Access Report

Max McMahon Oval
Weblands Street
Rutherford NSW 2320

For: Maitland City Council
Ref: PAA_23271

Figure 2 | Overall Site Plan

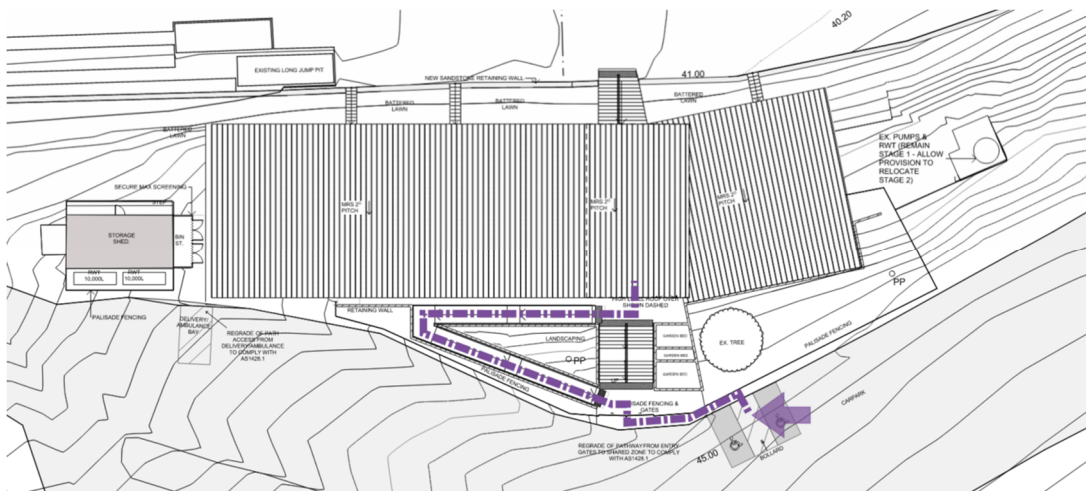
An accessible path of travel is provided to the building entrance via a formed footpath. Plans note that this will be compliant with AS1428.1.

Ensure that ground abutting the sides of the pathways follows the grade of the pathway and extends horizontally for 600mm. We note that this is not required where a kerb or handrail provided to the side of the pathway.

Ensure the maximum crossfall for the accessible carparking area is 1:40. This crossfall applies both parallel and perpendicular to the angle of parking.

Ensure that a bollard is provided to the shared space.

The ramp is designed in four sections in a switch back arrangement. The configuration is compliant with AS1428.1.

Ensure that a kerb or kerbrails are provided as necessary where ramp is not enclosed.

Ensure that the detailed design includes the provision of contrasting non-slip nosings to treads and tactile indicators top and bottom.

Tiered seating, with stairs, is provided between the new building and the oval. We note that currently, a wheelchair can only access the top tier of the seating area. This is acceptable under the BCA.

A hob has been provided for wheelchair seating off the path of travel. A handrail with kerbrails has been provided at the top tier for safety.

Ensure the provision of tactile indicators at the top and bottom of each change room access stair.
